TECHNICAL SERVICE BULLETIN Glove Compartment Misaligned

19-2206
27 June 2019

This bulletin supersedes 19-2071. Reason for update: New Part/Procedure For Same Condition

Ford 2015-2019 F-150

Figure 1

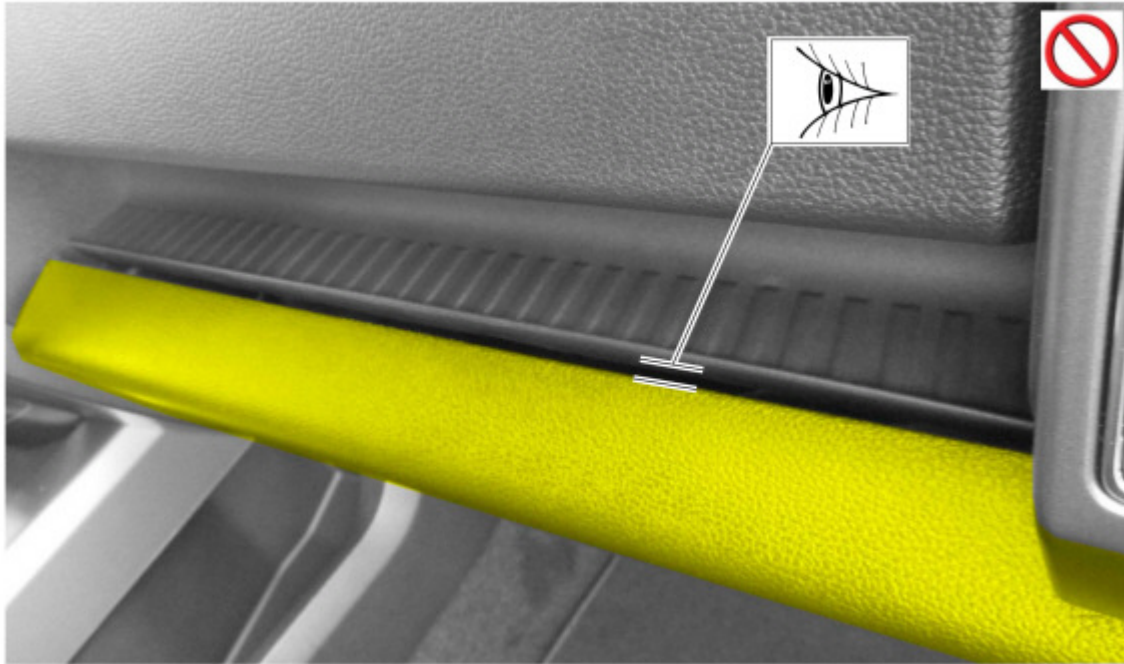
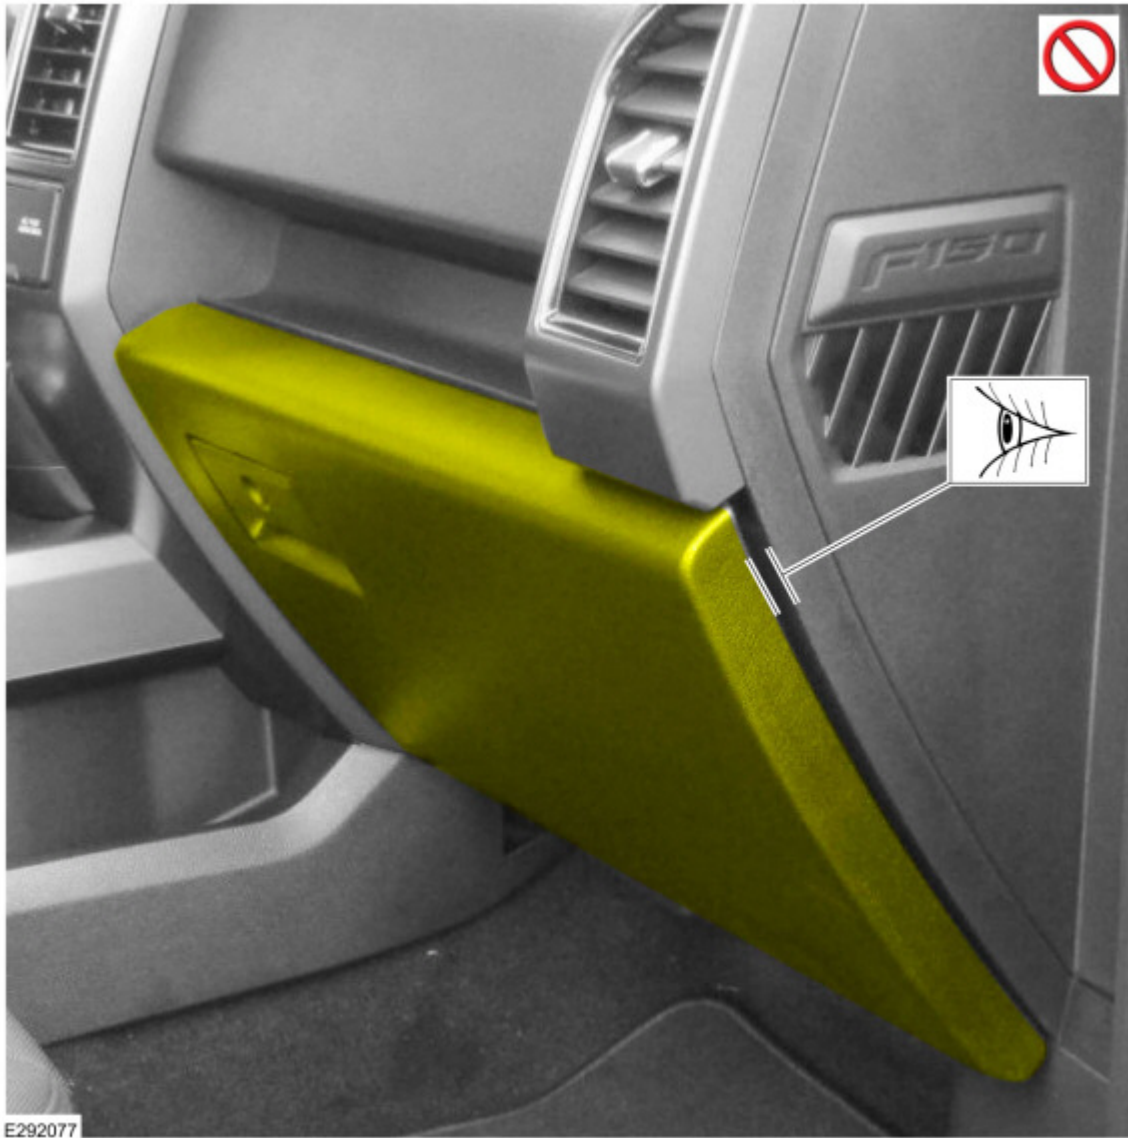
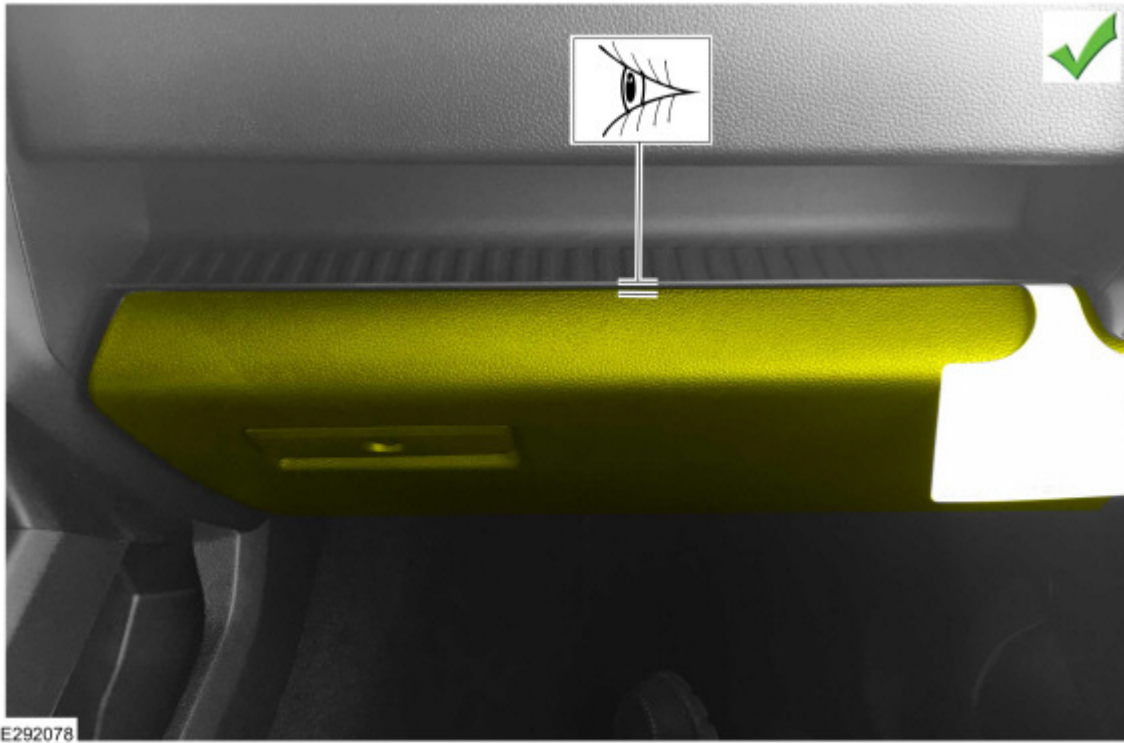
1. Inspect the glove compartment door in the closed position. Does the glove compartment exhibit a misalignment at the storage tray and/or right side instrument panel with no other visible defect? (Figures 1-4)

(1). Yes - proceed to Step 2.

(2). No - this article does not apply. Refer to the Workshop Manual (WSM), Section 501-12 for normal diagnostics.

Figure 6

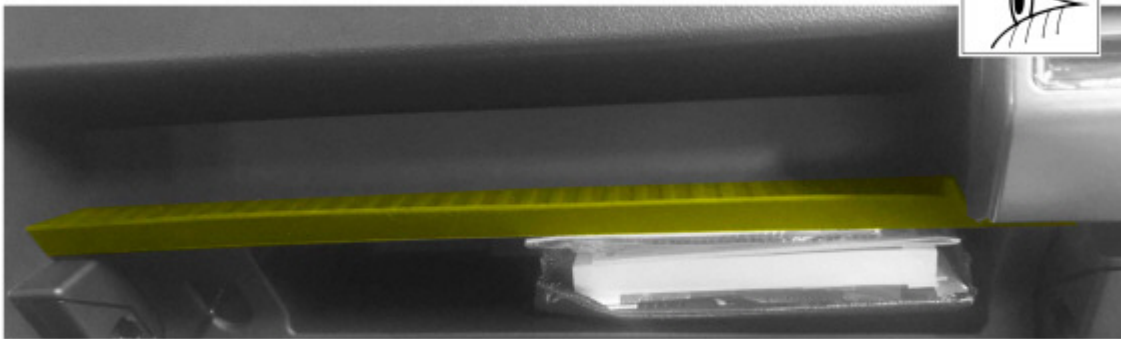
2. Inspect the glove compartment storage tray rubber mat. Is the mat properly seated and flush on both ends of the instrument panel? (Figures 5-6)

(1). Yes - proceed to Step 4.

(2). No - proceed to Step 3.

Figure 7

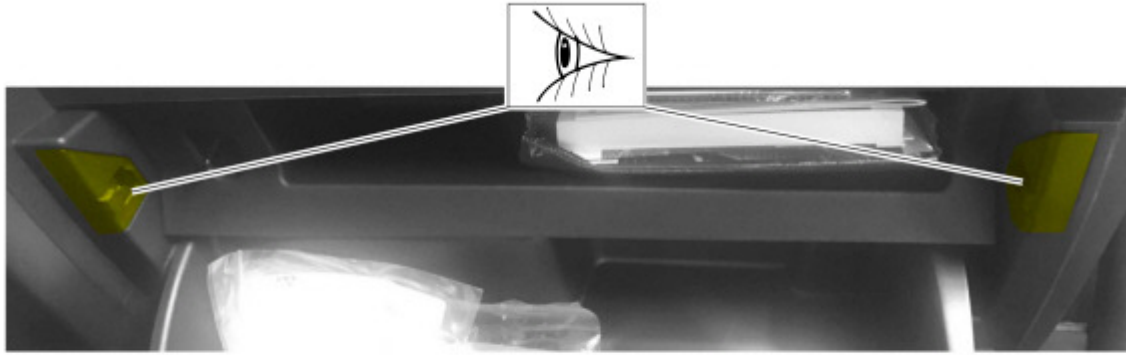
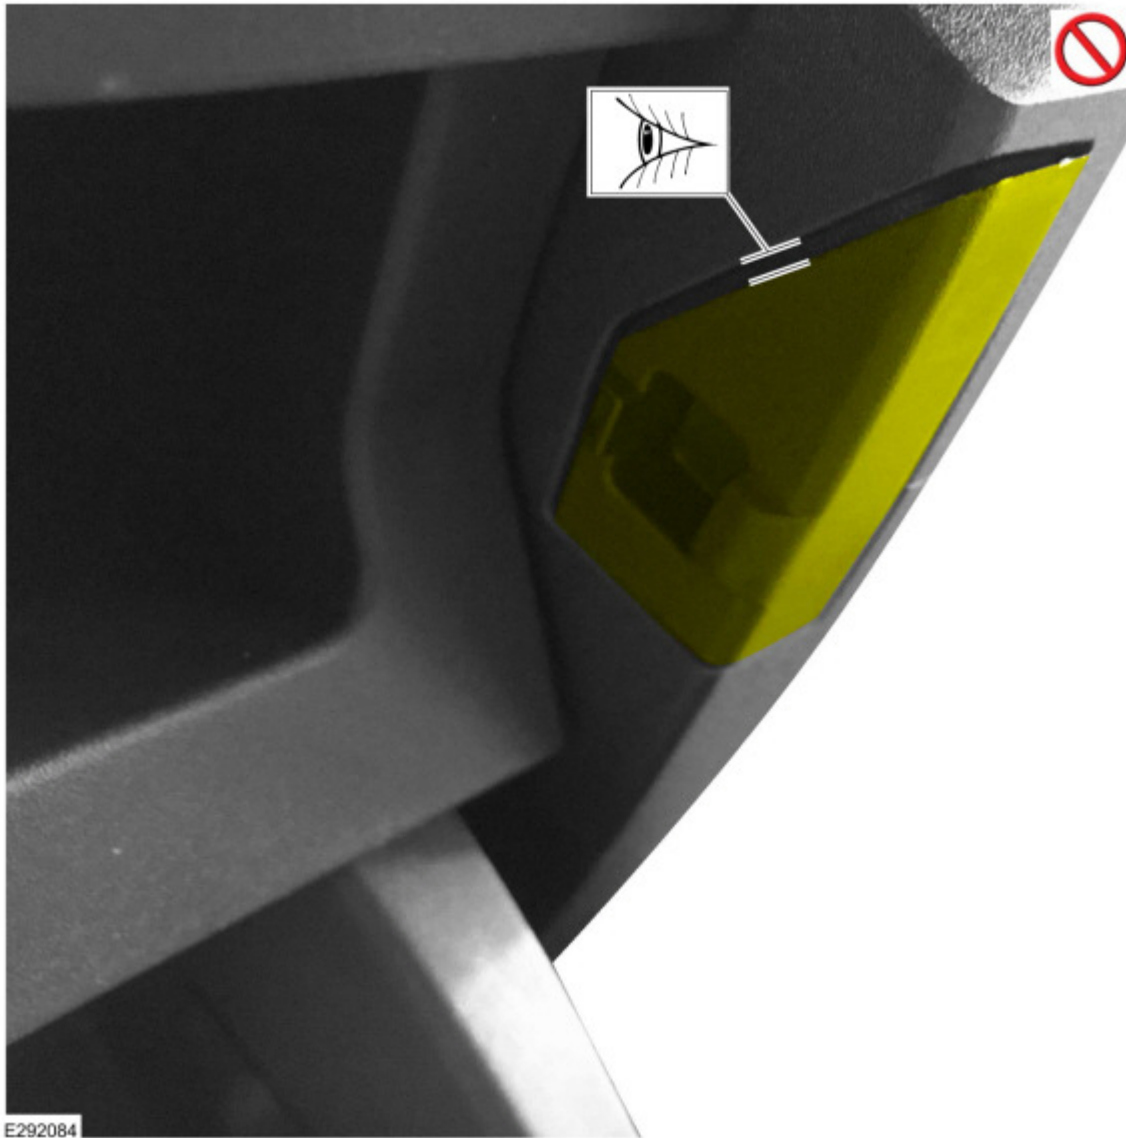
3. Remove the rubber mat and close the glove compartment door. Refer to WSM, Section 501-12. Does the glove compartment door close properly?
 - (1). Yes - The rubber mat was installed incorrectly. Install the rubber mat making sure the right hand side is properly tucked and seated to the instrument panel. Refer to WSM, Section 501-12. Proceed to Step 4.
 - (2). No - install the rubber mat and proceed to Step 4. Refer to WSM, Section 501-12.
4. Inspect the glove compartment door left and right side strikers. Are the strikers fully seated? (Figures 7-9)
 - (1). Yes - proceed to Step 6.
 - (2). No - proceed to Step 5.

5. Remove the improperly installed striker using a non-marring pry tool and reinstall. Make sure the striker is fully seated.
6. Inspect the glove compartment door hinge pins. Are both pins fully seated? (Figure 10)
 - (1). Yes - proceed to Step 8.
 - (2). No - proceed to Step 7.
